Item # 8
MCPB 06/15/06

MEMORANDUM

REVIEW TYPE: **Site Plan Review**
CASE #: **820060310**
PROJECT NAME: Montgomery Industrial Park
APPLYING FOR: Approval of a 104-room hotel on 1.69 acres
REVIEW BASIS: Div. 59-D-3 of Montgomery County Zoning Ordinance

SHEET NUMBER: A-4.1

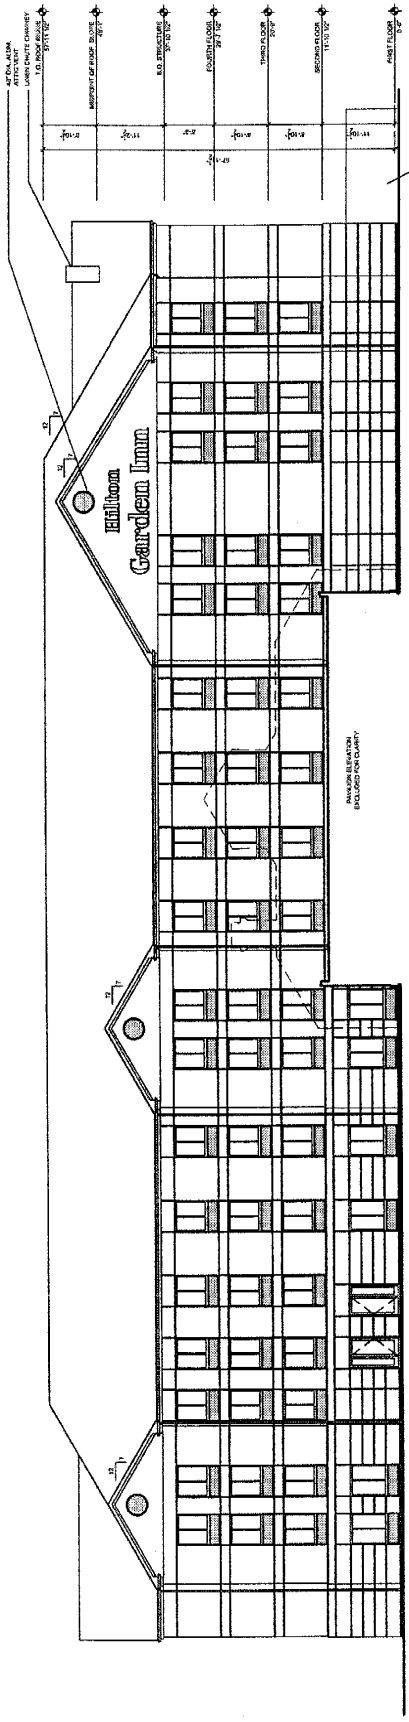
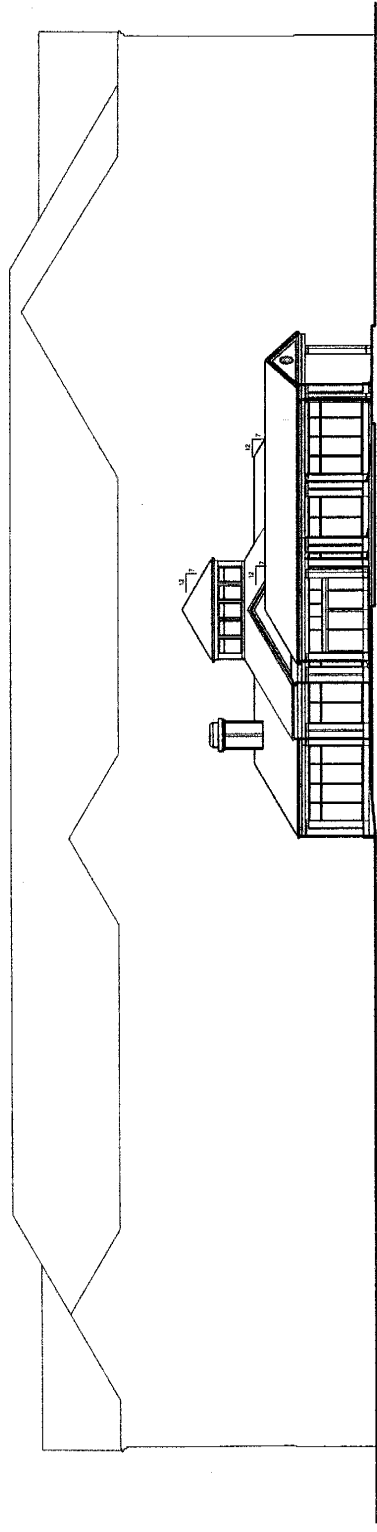
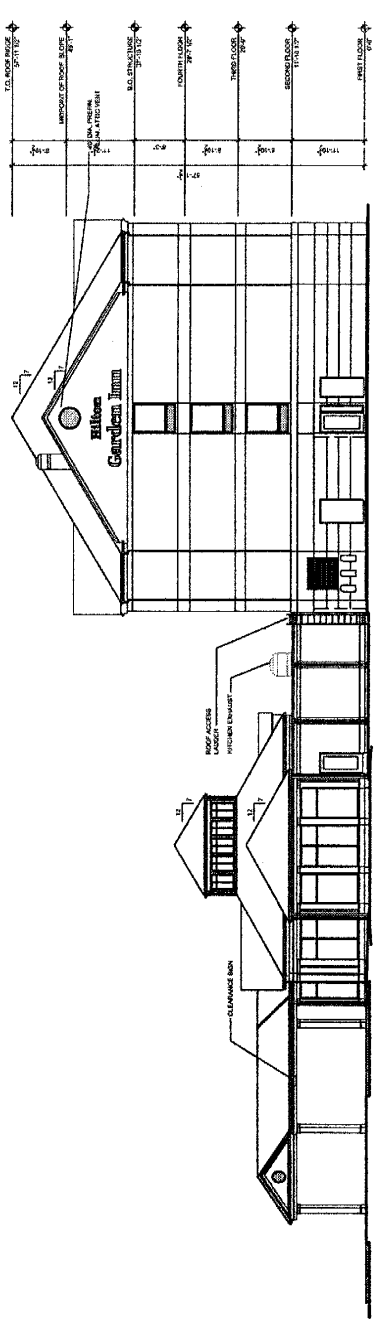
The building is T-shaped and situated parallel to the eastern property boundary. The height of the proposed building measured from the average grade around the front of the building to the mid point of the proposed gable roof will be approximately 52 feet, three feet less than the 55 feet maximum height approved by the Board of Appeals. The architectural drawings and final grading plans are not complete, however, and the roofline is subject to change, as are the final grades. The architectural elevations indicate a proposed average grade and that the final height will be between 51 and 55 feet. This is to anticipate any construction drawings and to minimize future site plan amendments. Staff believes that there are no compatibility issues with the height of the building if it is set at a maximum of 55 feet and four stories in accordance with the approved special exception.

- a. Buildings: The location of buildings and structures is adequate, safe, and with the changes to the entrance area, efficient. The proposed building height will be 55' or less in conformance with the maximum height established in the special exception.
- b. Open Spaces: The site plan shows 37.2% green space, which is greater than the minimum 15% green space required in the I-1 zone.
- c. Landscaping and Lighting: The proposed landscaping plan, if the Board grants a wavier for the location of shade trees, conforms to the requirements of Sec.59-E.2.7.2. Staff has requested that the required shade trees be relocated to provide shade and to ensure that there is no disturbance near wetland buffer.

LANDSCAPE PLAN
LOT 39, BAYWOOD HOTEL

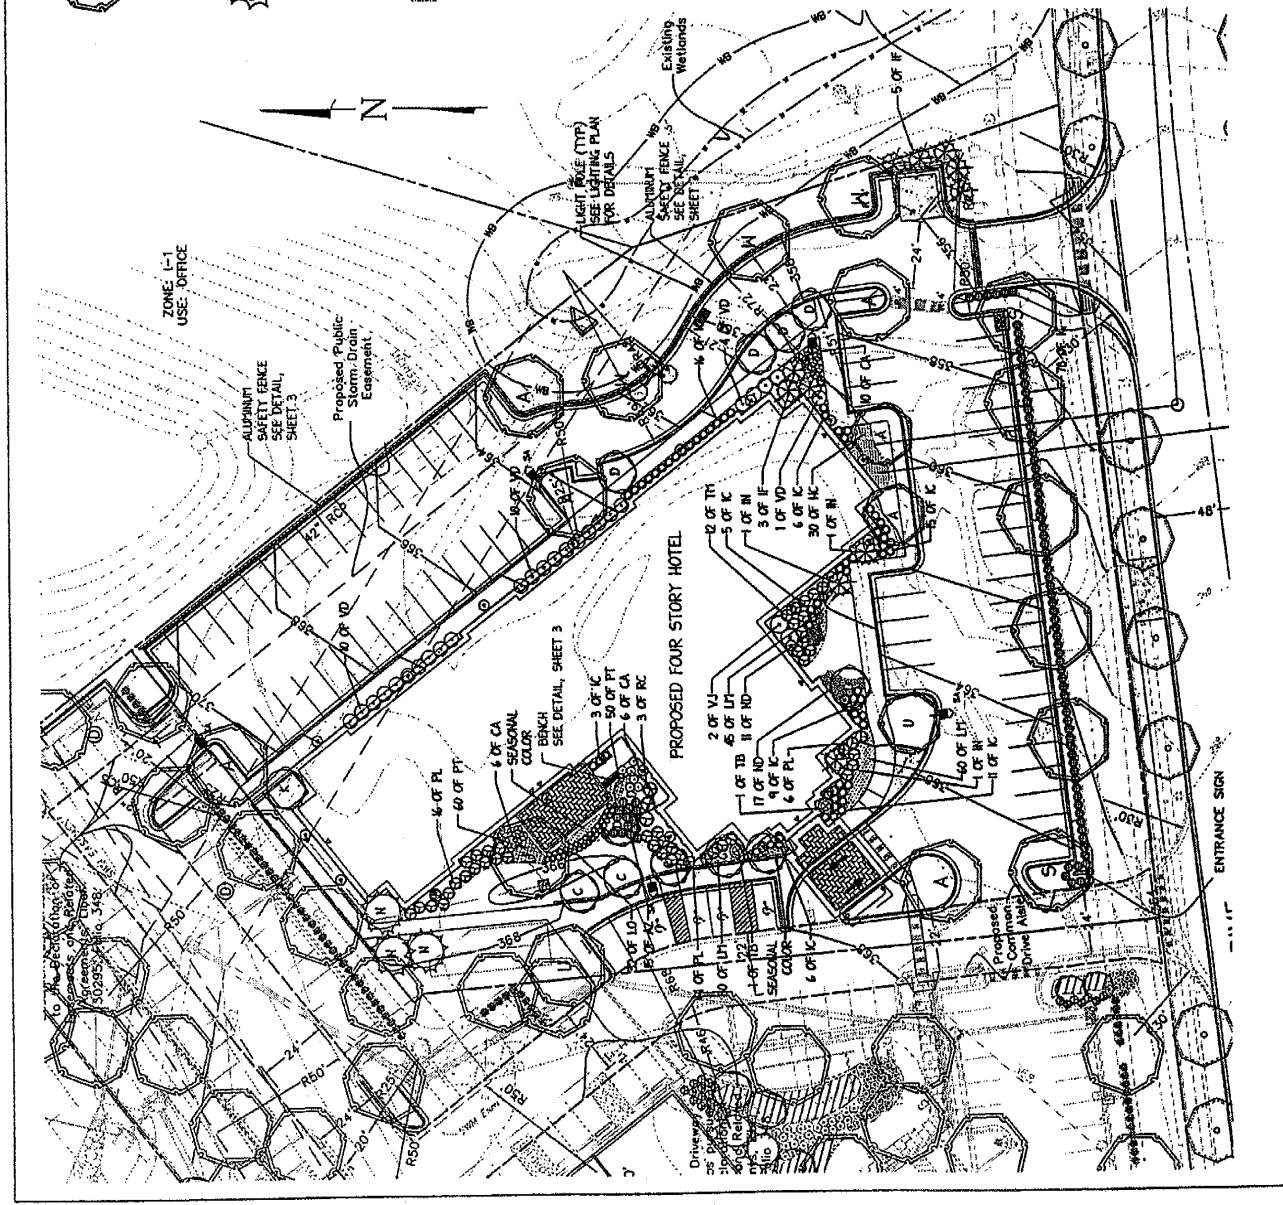
Section 59 E-2.7.2 of the Zoning Ordinance requires a perimeter-landscaping strip at least four feet wide. Such area shall contain a minimum of one shade tree for every 40 feet of perimeter. The portion of the parking facility that abuts the adjoining property measures 155 feet and would require four shade trees. This is also the area where a retaining wall measuring between two and three feet in height is necessary to match the existing grade of the stormwater management facility and wetland buffer.

There will be an aluminum safety fence along this retaining wall to keep individuals and cars off the retaining wall and will also serve to screen the cars from the adjoining site. The regulations require shade trees to be planted along this edge. Staff recommends that the Planning Board grant a waiver for the location of the trees, not the number of trees, on the basis that the safety fence will provide screening and that the required shade trees can be located to the edges of the parking facility and still provide shade.

approval of a waiver from the zoning ordinance location requirements for shade trees along a parking facility (Sec. E-2.7.2.).
